Access Compliance Report Public Rights-of-Way (Curb Ramps)

Main Street: COUNTY_LN Cross Street: COUNTRY_HAVEN_LN Location: SW

ADA ID: RPRK211007181656 Ramp Type: Type 1 - Perpendicular Diagonal Initial Pass/Fail: Fail Overall Compliance: No Severity Score: 30

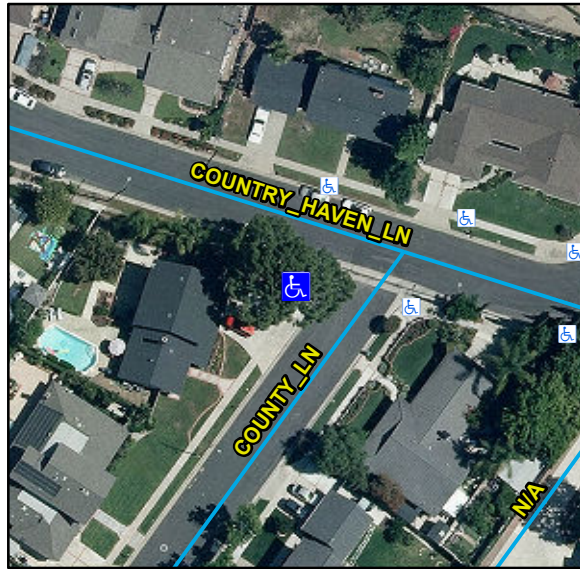
Compliance	Description	Data	Compliance	Description	Data
N/A	Ramp Length (in)	106	N/A	Flare Type LT	
Yes	Ramp Width (in)	48			N/A
No	Ramp Run Slope (%)	12.4	N/A	Flare Slope LT (%)	N/A
Yes	Ramp Cross Slope (%)	0.7	N/A	Flare Traversable LT	N/A
N/A	Landing Present	N/A	N/A	Flare Type RT	
N/A	Landing Length (in)	N/A			N/A
N/A	Landing Width (in)	N/A	N/A	Flare Slope RT (%)	N/A
N/A	Landing Run Slope (%)	N/A	N/A	Flare Traversable RT	N/A
N/A	Landing Cross Slope (%)	N/A	N/A	DWS Provided	N/A
N/A	Landing Movement Obstructed?	N/A	N/A	DWS Contrast	N/A
	Landing Movement Type	N/A	N/A	DWS Length (in)	N/A
N/A	Landing Shared	N/A	N/A	DWS Full Width	N/A
N/A	Clear Space	Yes	N/A	DWS Offset Left (in)	N/A
N/A	Clear Space To Crosswalk (in)	N/A	N/A	DWS Offset Right (in)	N/A
N/A	Marked Crosswalk 1	No	N/A	Marked Crosswalk 2	No
	Crossing 1 Direction	E		Crossing 2 Direction	N
	Marked Crosswalk 1 Width (in)	N/A		Marked Crosswalk 2 Width (in)	N/A

N/A	Ramp Inside Crosswalk 1	N/A	Yes	Ramp Inside Crosswalk 2	N/A
	Crossing 1 Slope (%)	8.2		Crossing 2 Slope (%)	4.8
	Crossing 1 Cross Slope (%)	2.7		Crossing 2 Cross Slope (%)	2.2
N/A	Gutter Ponding	N/A	No	Curb Slope	15.6
No	Gutter Lip Height (in)	0.5		Road Run Slope (%)	2.1
N/A	Gutter Run Slope (%)	N/A		Road Cross Slope (%)	4.4
N/A	Gutter Cross Slope (%)	N/A			
Yes	Overall Surface Condition: Acceptable		Yes	Perp Joint Present	Yes
	Cross Gutter Present?	Yes		Spandrel Present?	Yes
	Replace Cross Gutter?	No		Replace Spandrel?	No

Possible Solutions:

Remove & Replace Curb Ramp With Two New Directional Ramps or Equivalent.
